A complete set of current Electronic Typewriter CEMs consists of Combined Service Information booklet, CEMs starting on page 1, and the Technical Information Index.

237 SERVICE INFORMATION 7-29-81

Type(s): 6713, 6723 (US Only) (Revised) 1-26-83

SUBJECT: ELECTRONIC TYPEWRITER DIAGNOSTIC TOOL (XTDT)

Figure 1

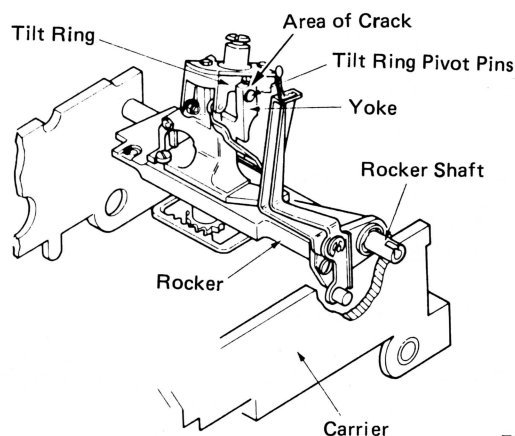
Poor print quality, especially of the underscore, may be caused by a crack in the yoke near the tilt ring pivot pins. (Figure 1)

If the yoke is found to be cracked, replace the rocker asm. (2-450: Part Number 1440310) rather than the carrier asm. A method of removing the rocker is as follows:

1. Remove cardholder bracket asm. (2-493).
2. Disconnect shift mode switch (3-309).
3. Loosen the rocker pivot shaft retaining screws (2-6, 2-404).
4. Remove rocker pivot shaft retaining "C"-clip (2-274).
5. Remove rocker return spring (2-313).
6. Slide rocker pivot shaft to the left until the shaft is out of the rocker asm. (2-272). [Holding the thrust washer (2-271)].
7. Remove the rocker asm. (2-450).
8. Install new rocker asm., reverse steps 1-6.
9. Check all related selection adjustments.

Figure 1

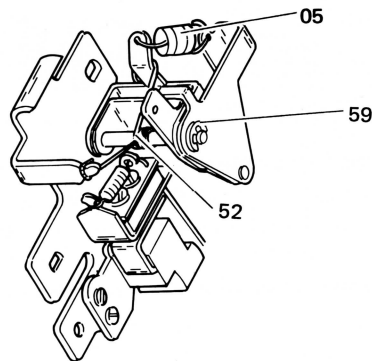
If experiencing piling, chugging (Model 50/60) or system busy (Model 75) install the redesigned knockoff arm return spring (06-52). This spring provides more reliable inhibitor restoring and increases the escapement magnet seal force. The old knockoff arm return spring should be removed and discarded.

To install the spring remove the C-clip (06-59) and slide the components on the stud to the left until the spring can be installed, then reassemble. The override spring (06-05) may be removed to facilitate installation.

Figure 1

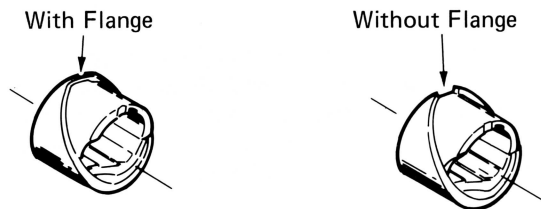
Some Ribbon Cassette System machines contain tape lift and feed cams (02-498) without a flange on the low dwell of the tape lift camming surface (Figure 1). A missing flange does not affect tape lift and will not cause correcting tape lift failures.

Figure 1

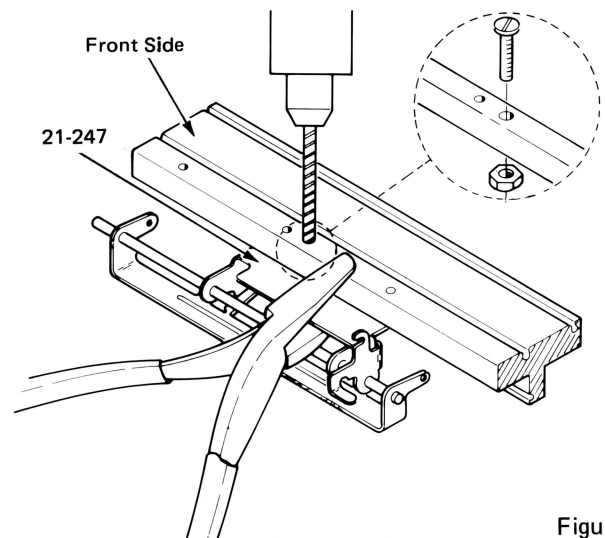
If the keyboard bellcrank mounting bracket screw (21-249) breaks and the remaining part of the screw cannot be removed, use the following procedure. Remove the keyboard assembly (21-264, 265) and drill a hole (Fig. 1) through the frame (08-16) and the bracket (21-247) alongside the existing screw, using a #29 drill bit (P/N 0450163). Install a new screw (P/N 1164581) and a nut (P/N 1134842). The nut should be installed on the rear side of the frame.

NOTE: To facilitate the drilling, the frame and the bracket may be held together with duck bill pliers.

Figure 1

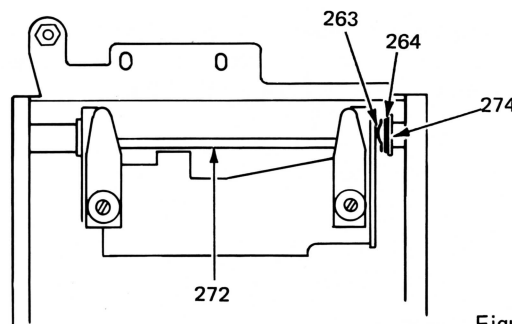
A compression washer (02-263) and a flat washer (02-264) have been added between the rocker and retaining C-clip (02-274) on the rocker pivot shaft. The washers eliminate rocker end play and reduce rocker "bounce" during a repeat underscore. The rocker shaft (02-272) has been modified by increasing the length of the flat area.

When experiencing inconsistent print quality and/or voids in low velocity repeat characters and all print adjustments are correct (particularly velocity cam follower clearance), install the compression washer B/M (02-270). Lubricate the washers before assembly with a film of #23 grease.

Adjust the rocker shaft to compress the washer without causing an excessive bind. To do this, half cycle the print shaft and load the rocker shaft to the left with a minimum of 6 lbs. of force to compress the washer (a spring scale may be used). Then tighten the retaining screws (02-6, 404). While still half cycled check for binds by manually moving the rocker to the print position. The rocker must restore completely under tension of the restoring spring.

Figure 1

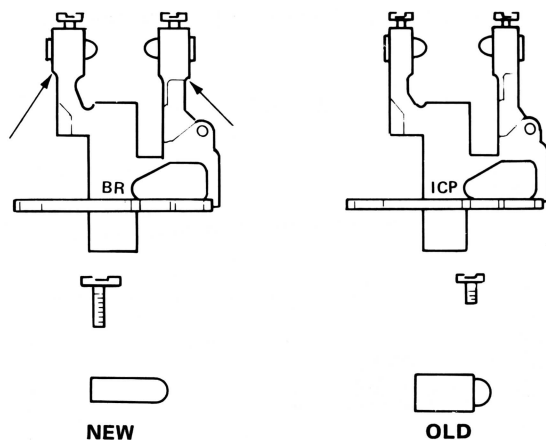
Carrier yokes (02-275/276) have been redesigned to prevent cracking around the tilt ring pin screw (02-269) hole. These yokes will have thicker uprights and use smaller diameter tilt ring pins (02-278) and longer tilt ring pin screws (02-269). See Figure 1.

Figure 1

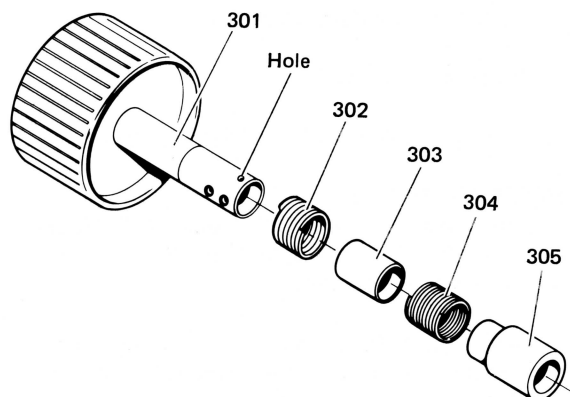
An override clutch has been added to the left end of the platen assembly. The clutch prevents index and alignment failures caused by inconsistent drive in the index mechanism.

1. Remove and discard the left platen knob (22-301), left bushing (22-305), and the washer between the index emitter wheel (23-20) and the c-clip (23-21).
2. Insert the extension of the override spring (22-302) into the hole in the new platen knob shaft (Figure 1).

Figure 2

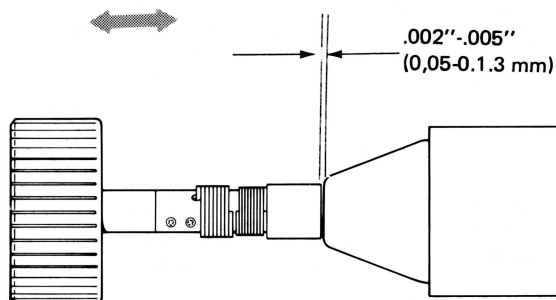
3. Lubricate the inside of the springs (22-302/304) with #23 grease and install the new parts on the platen shaft (Figure 1).
4. Adjust the end play of the clutch (Figure 2).

Figure 1

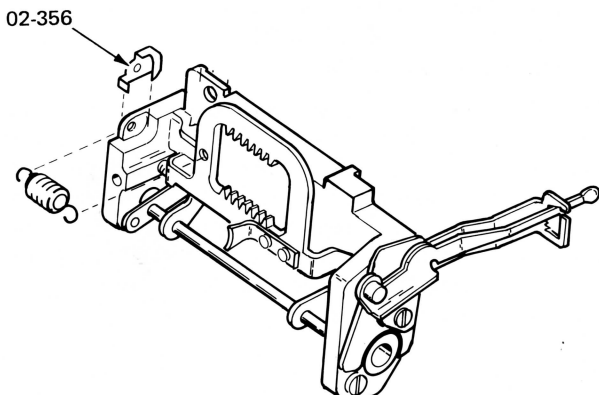
A wear prevention clip is now available to prevent the rack return spring (02-298) from wearing through the rocker casting (02-289). The clip also provides a new surface if the rocker casting is partially worn or completely worn through. The existing spring will be used with the clip.

Note: Squeezing the clip together slightly before installing will help hold it in place while remounting the spring (Fig. 1).

Figure 1

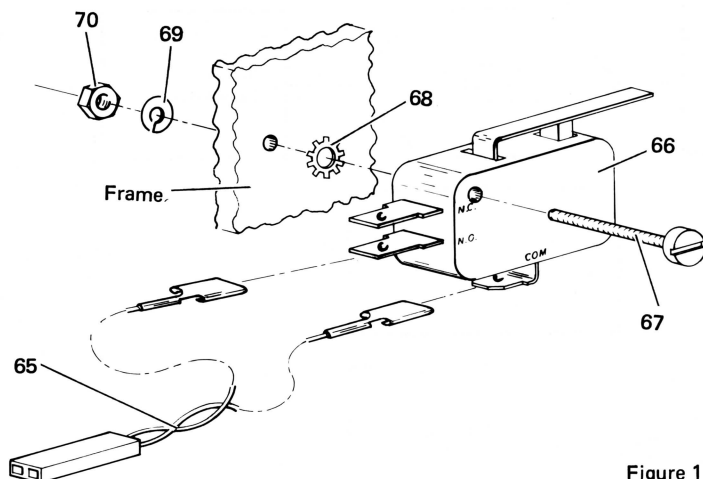
The Electronic Typewriter 65 has no "Advance" or "Return" button on the message panel; therefore, a service switch (Fig. 1) has been added in order to access the tests previously mentioned. To enter these specific tests, the service switch is used exactly as the "Advance" button is used on the IBM Electronic Typewriter 85.

Figure 1

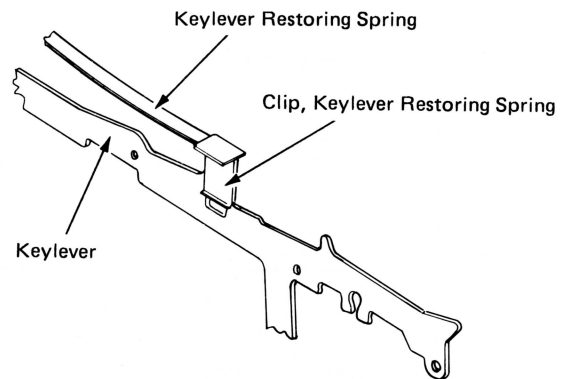
A single operation keylever restoring spring clip (21-85) and a repeat operation keylever restoring spring clip (21-86) are now available for use on Electronic Typewriters Model 50/60/75. These clips will prevent the keylever restoring spring (21-74, 80) from slipping off the keylever.

When installing either clip remove top section of the keyboard (21-084). To install a single-operation keylever restoring spring clip, slide the flat part of the clip on the restoring spring first (Fig. 1).

Figure 3

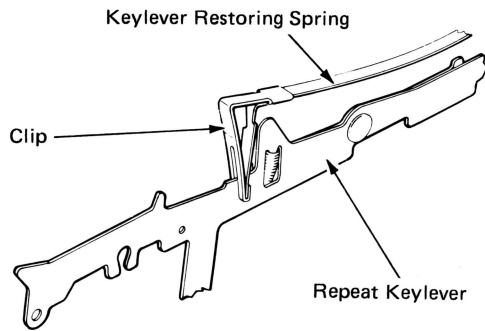
On repeat operation keylevers install the clip as follows; depress the keylever and install the hooked portion of the clip over the intermediate keylever (Fig. 2). Then slide the flat part of the clip over the keylever restoring spring (Fig. 3).

Figure 1

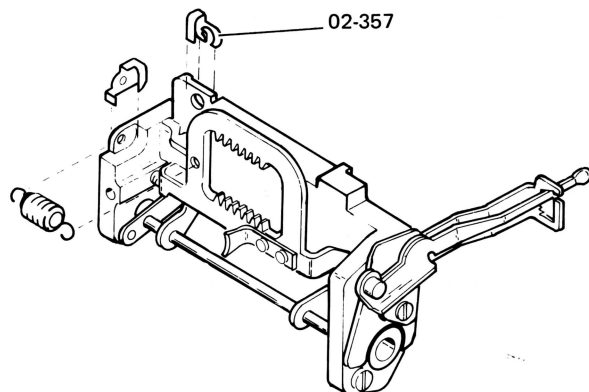
A wear prevention clip is now available to prevent the rocker return spring (02-313) from wearing through the rocker casting (02-289). The clip also provides a new surface if the rocker casting is partially worn or completely worn through. The existing spring will be used with the clip.

Figure 1

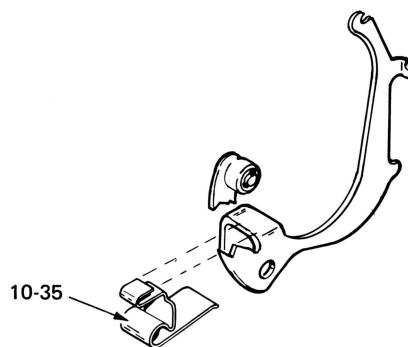
A cycle clutch latch support has been released for field use. This support will reduce PSCC extra cycles caused by the latch not holding the sleeve.

To install the support, remove the print shaft belt, the PSCC backcheck pawl (10-44) and the restore arm (10-71). Slide the support onto the restore arm (fig. 1) and re-install the restore arm (fig. 2), the backcheck pawl, and the print shaft belt.

Figure 1

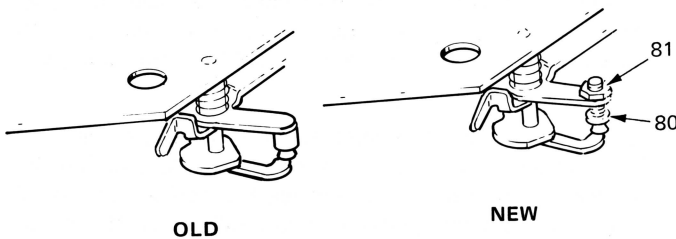
The tape lift cam follower has been redesigned to provide a more consistent method of adjusting its height. The follower is now threaded through the follower bellcrank and is adjusted with a bristol wrench. A nut secures the adjustment.

3. With the correcting control arm (02-501) on the high point of the correcting restore cam (02-499), adjust the correcting control arm eccentric (02-503), for .012" to .020" clearance between the latch surface of the correcting control arm and the erase latch. Keep the eccentric toward the rear.

NOTE: Update APM frame 156 to show new adjustment specification.

Figure 2

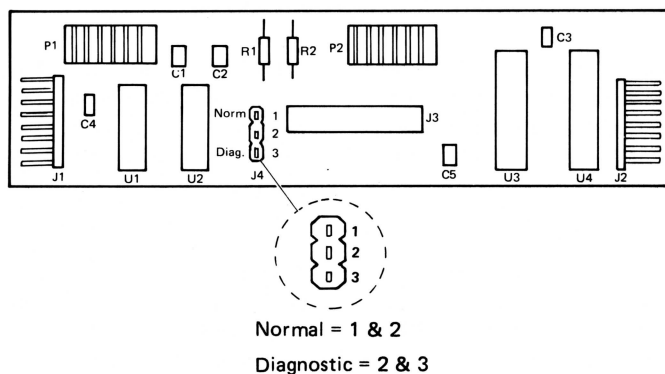
6. Turn the motor switch off. Move the Interface Board Diagnostic Jumper to the diagnostic position, Fig. 2. Turn the motor switch on.

Figure 1

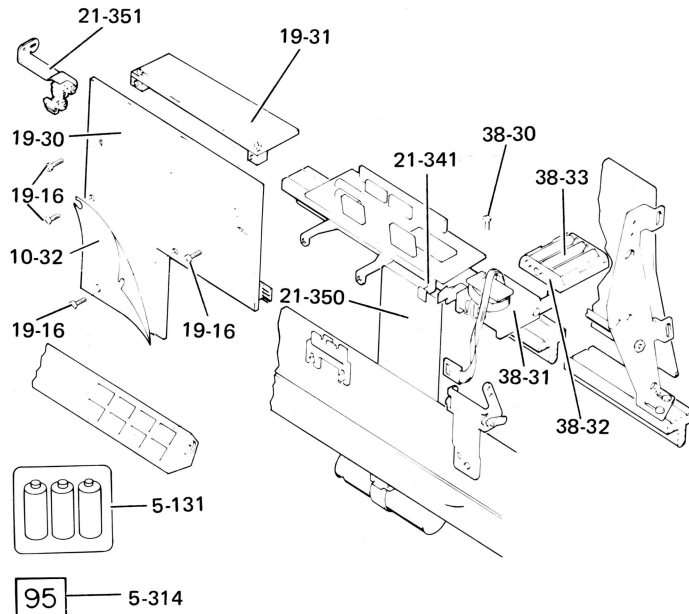
and an identifying **logo**. The battery container cable attaches to the logic board at a new L11 connector and is long enough to allow the logic board to be removed from the machine for diagnostic purposes without losing memory. For 32K memory the addition of a +16K board is required. See Figure 1 for component locations.

Figure 2

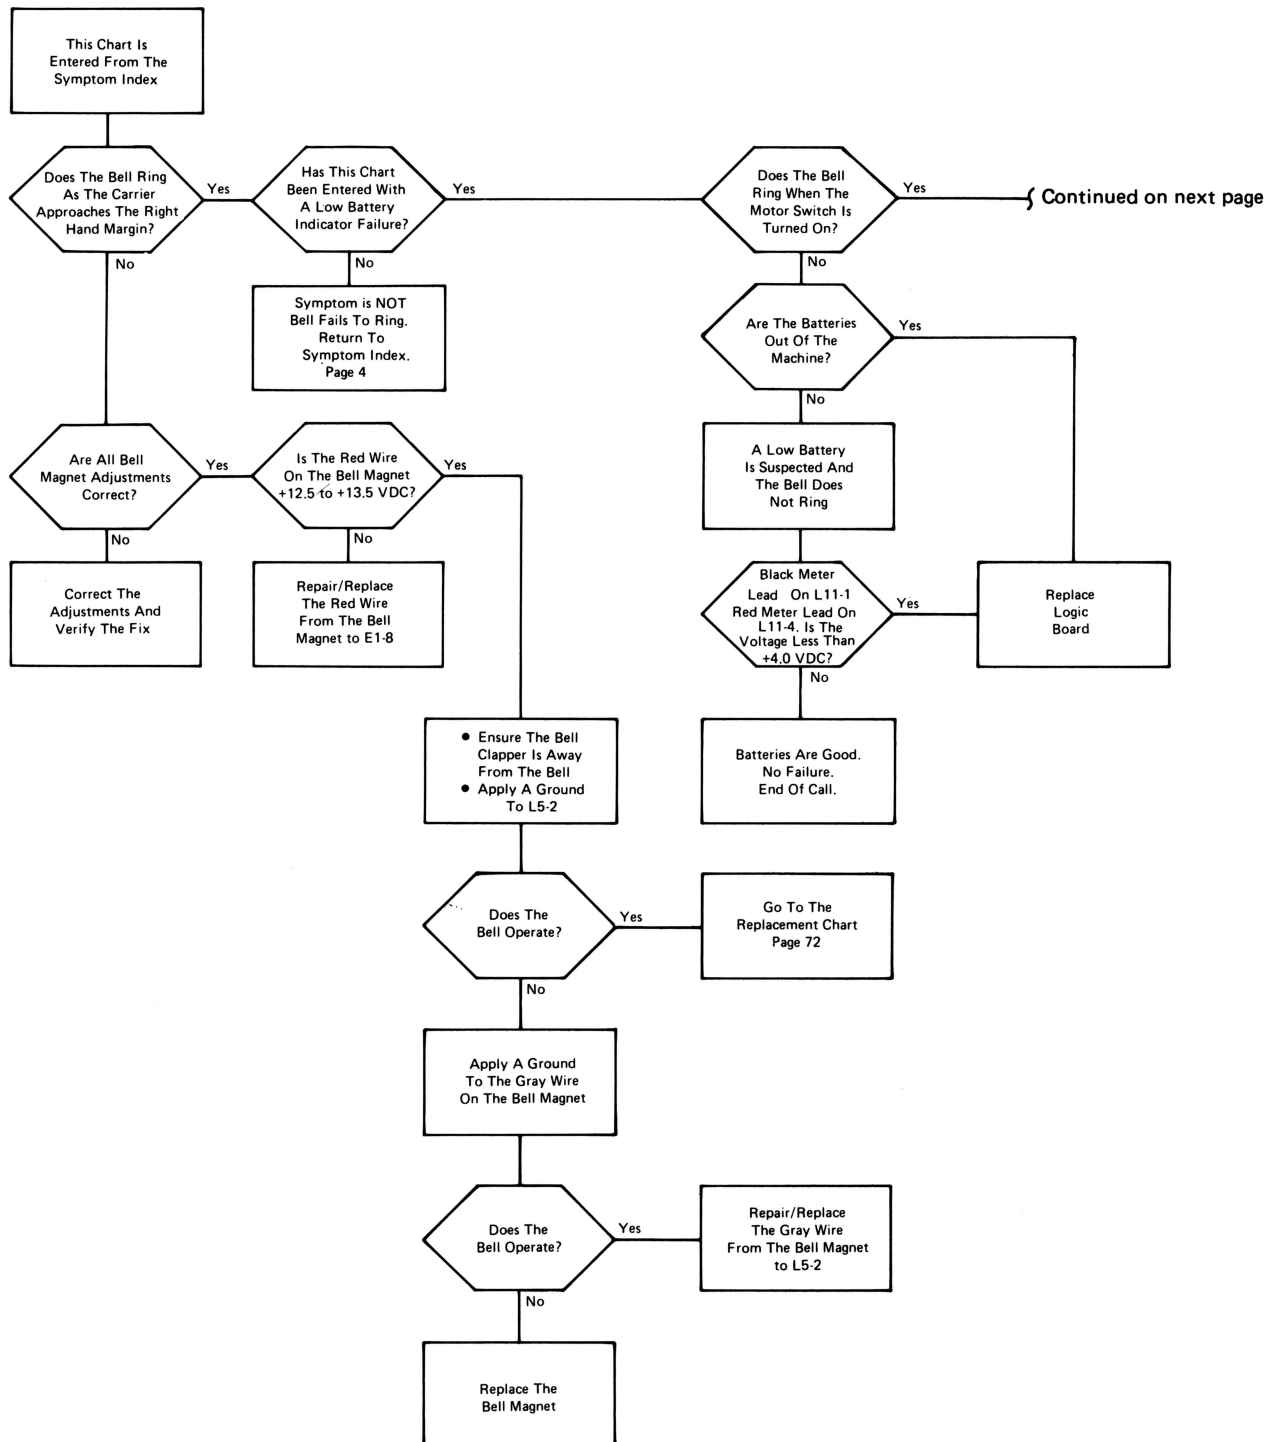
Three diagnostic charts have been changed to reflect a machine with Extended Memory Protection installed. These are the Bell Chart (Figure 2), the Replacement Chart 1 (Figure 3), and the Replacement Chart 2 (Figure 4).

Figure 1

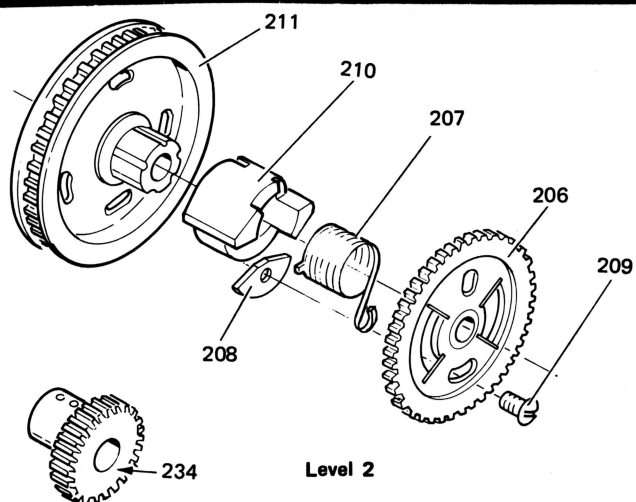
NOTE: The Print Shaft Cycle Clutch Spring adjustment has been changed to .030" - .055" (0.76 - 1.4 Omm).

Figure 1

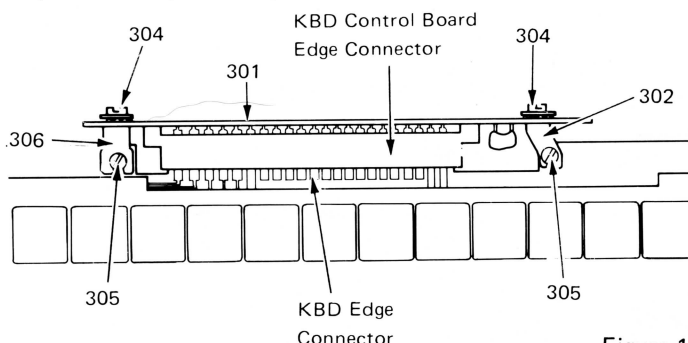
When a malfunctioning row or column of keybuttons is encountered, the problem may be caused by poor connection between the keyboard control board (21-301) and the keyboard (21-303). The following procedure can be used to correct this problem: Loosen keyboard logic clip mounting screws (21-305), disconnect keyboard control board (21-301) from keyboard and clean the keyboard edge connector (visible oxidation may be cleaned with an eraser). Loosen both keyboard logic mounting screws (21-304). When reinstalling the parts, tighten keyboard logic clip mounting screws (21-305), before tightening the keyboard logic mounting screws (21-304). This procedure will help eliminate any stressful condition between keyboard edge connector, keyboard logic mounting clips (21-302, 306) and keyboard control board. (Figure 1)

NOTE: Some early level keyboard logic mounting clips (21-302, 306) were shorter and affected the edge connector's reliability by forcing the top of the connector upwards, opening its contacts. If, when reconnecting, the keyboard control board edge connector and the keyboard edge connector cannot be aligned without downward pressure to the connector, replace the keyboard logic mounting clips.

Figure 1

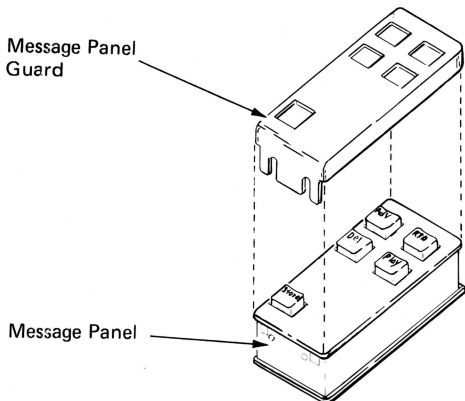
A message control panel guard (20-75) is now available for installation on Models 65, 75, 85 and 95. The new guard, when installed, will prevent accidental depression of the message panel buttons. The guard can also be used to eliminate unwanted message panel operations when diagnosing system busy problems.

Figure 1

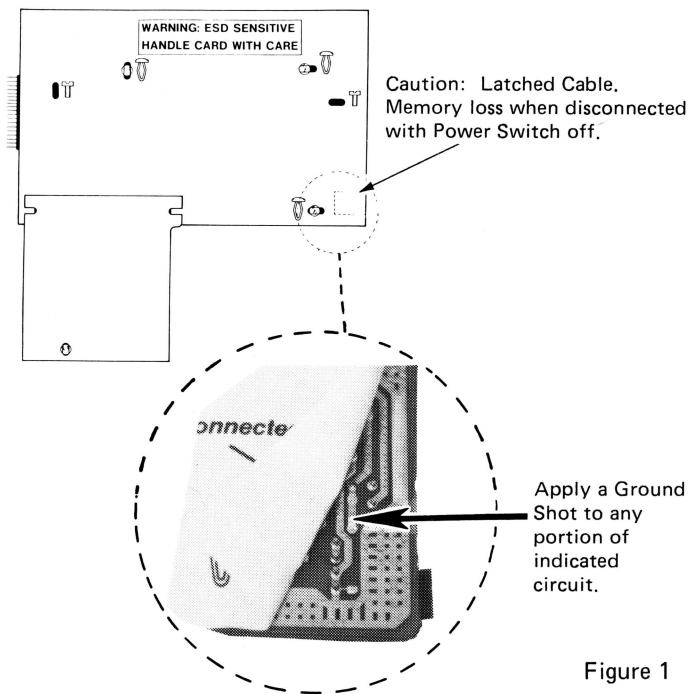
Apply a ground to the CMOS logic board as illustrated in Figure 1 prior to installation of either modularity option or +16K. Use the appropriate MES installation instructions for the remainder of the installation.

1. Main power off.
2. Remove the battery pak.
3. Connect one end of the meter probe to either frame ground or power supply ground.
4. Apply a ground as illustrated in Figure 1.
5. Install the link interface board or +16K board as needed.
6. Re-install the batteries.
7. Main power on.
8. Verify the machine operation.

Figure 1

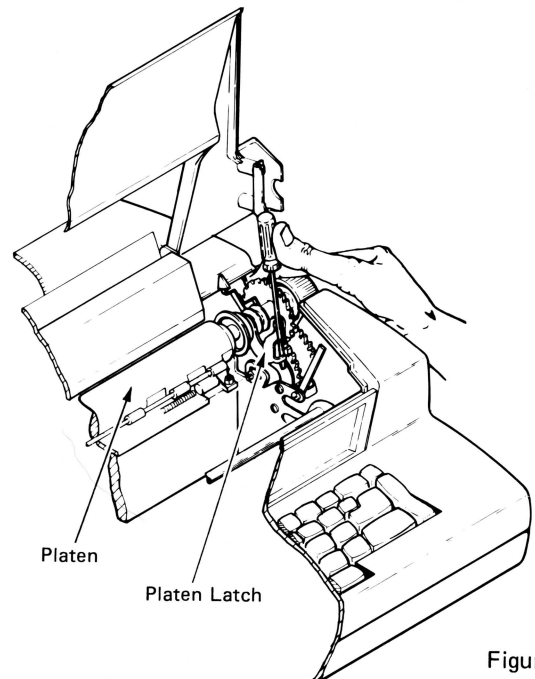
Care should be exercised to avoid trapping a finger between the RH platen latch and the top cover when removing the platen. Either of these suggested procedures may be used to remove the platen:

- A)
 1. Pull the platen detent release lever forward.
 2. Release both platen latches.
 3. Remove the platen.
- B)
 1. Insert the blade of a small screwdriver as shown in Fig. 1. (Note: Blade is positioned behind the RH platen latch stop lug.)
 2. Move the screwdriver handle to the rear, releasing the RH platen latch.
 3. Release the LH platen latch.
 4. Remove the platen.

NOTE: File smooth any rough edges found on the top cover in the area of the RH platen latch.
